**CITY OF NORTH ST. PAUL
PLANNING COMMISSION
REGULAR MEETING AGENDA
THURSDAY, AUGUST 2, 2018
6:15 PM**

A. Richardson Elementary School Site Plan Review and Variances

Date: 8/2/2018
To: Planning Commissioners
From: Erin Perdu, AICP, City Planner
CC: Craig Waldron, Interim City Manager
Paul Ammerman, Community Development Director
Re: Variances and Site Plan Review for Richardson Elementary

C401

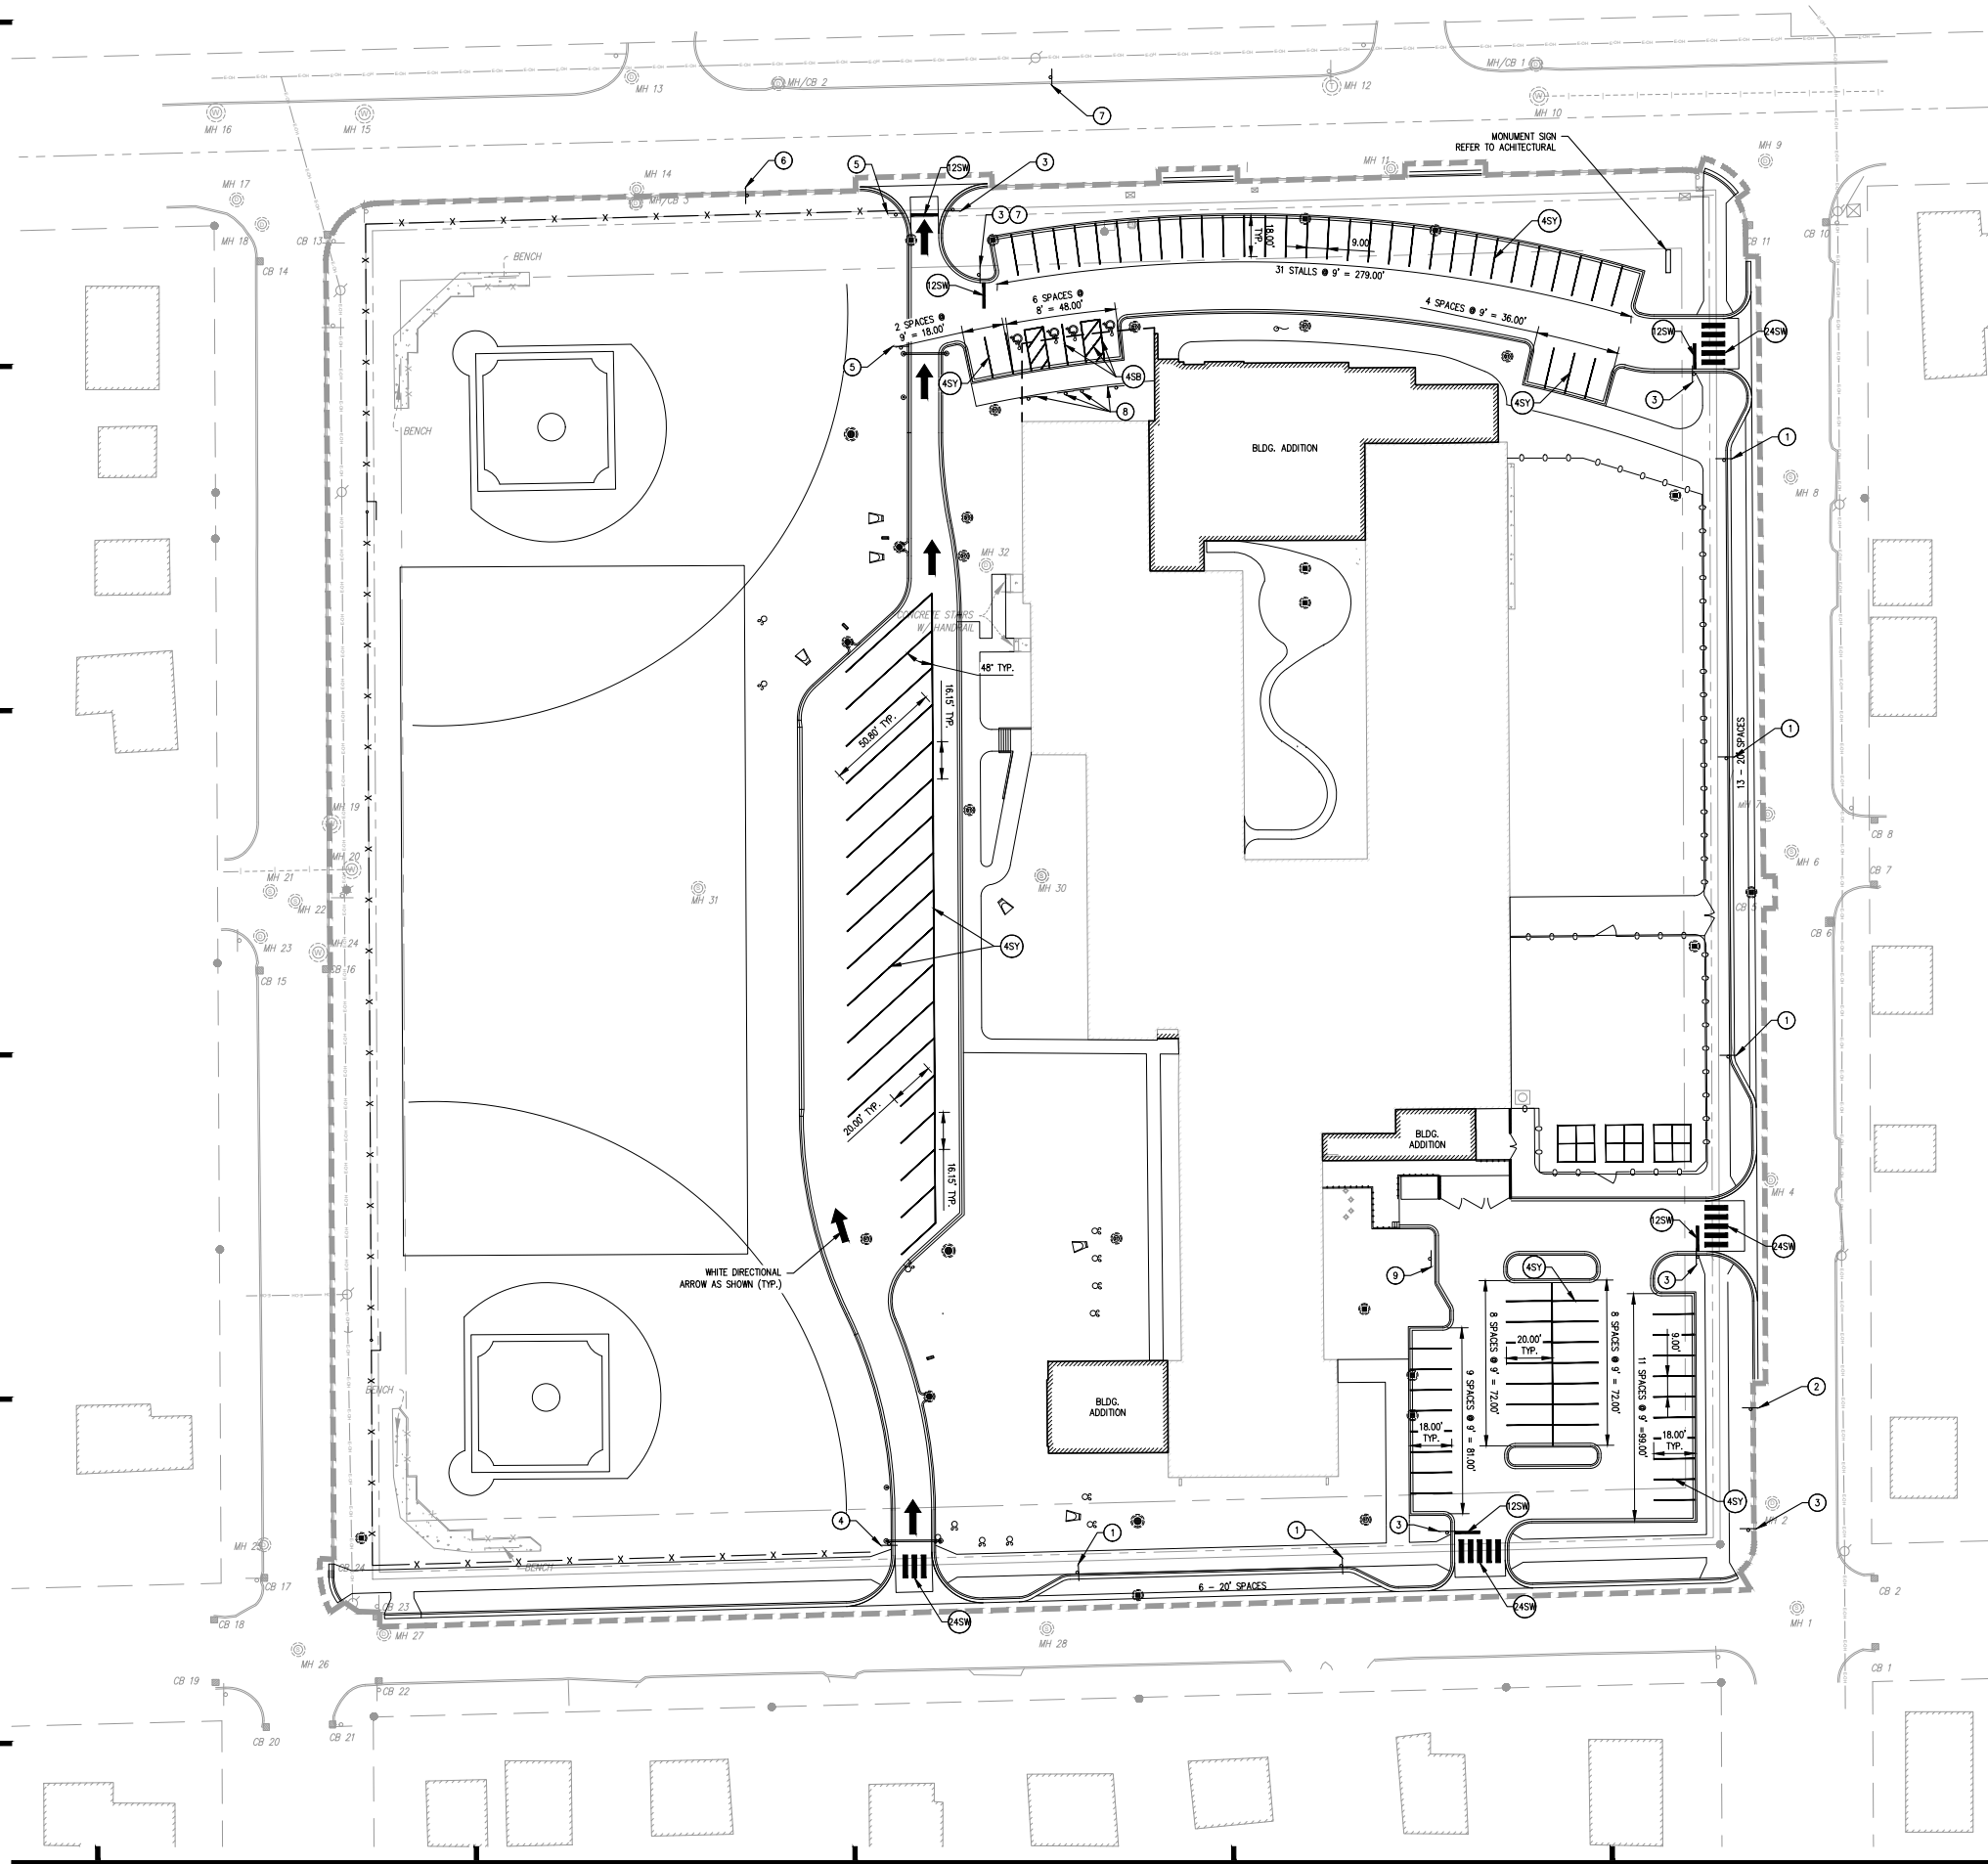
Sheet C401 & Sheet C502

2. The hatching for 6" Concrete Pavement in the legend does not match the hatch shown for 6" Concrete Walk on Sheet C401.
3. Verify that the curb type labels (D412, B612, etc.) shown on C401 match the typical sections shown on Sheet C502, especially those labeled as Typical Sections F-F and G-G.

3 DITCH CHECK
NOT TO SCALE

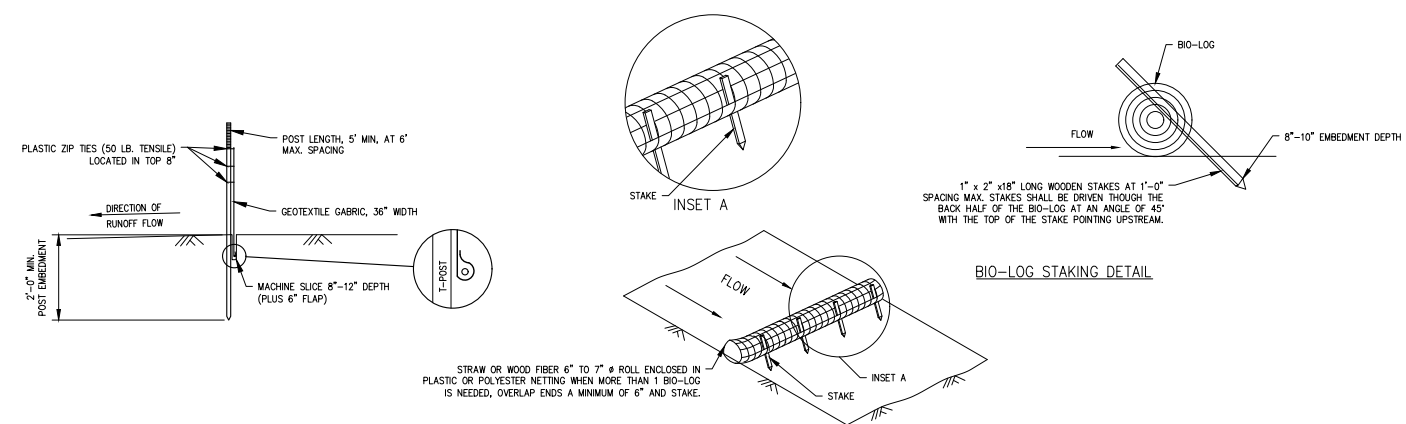
7. Detail 3 on page C501 shows a ditch check used for erosion control, however no ditch checks were located on the erosion control plans. Please callout location of ditch checks to be installed or remove the detail if no ditch checks are proposed.

2 TYPICAL CONCRETE APRON
NOT TO SCALE

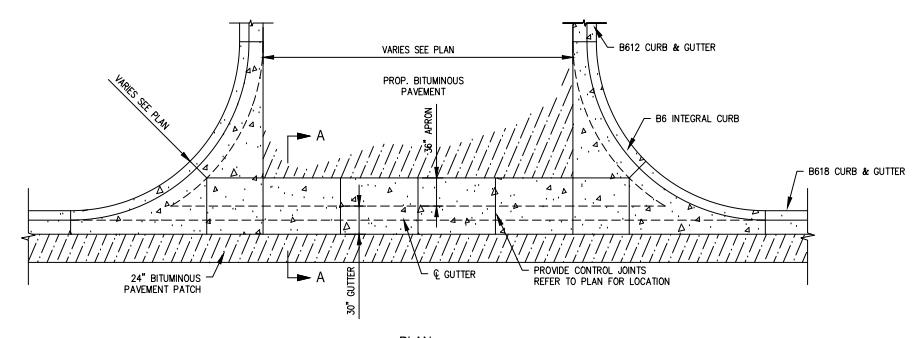
Sheet 507

1. Gutter widths shall be 36" according to City Standard Plates ST-7 and ST-8. Please review and revise details for 2. Typical Concrete Apron and 3. Typical Valley Gutter on this sheet.
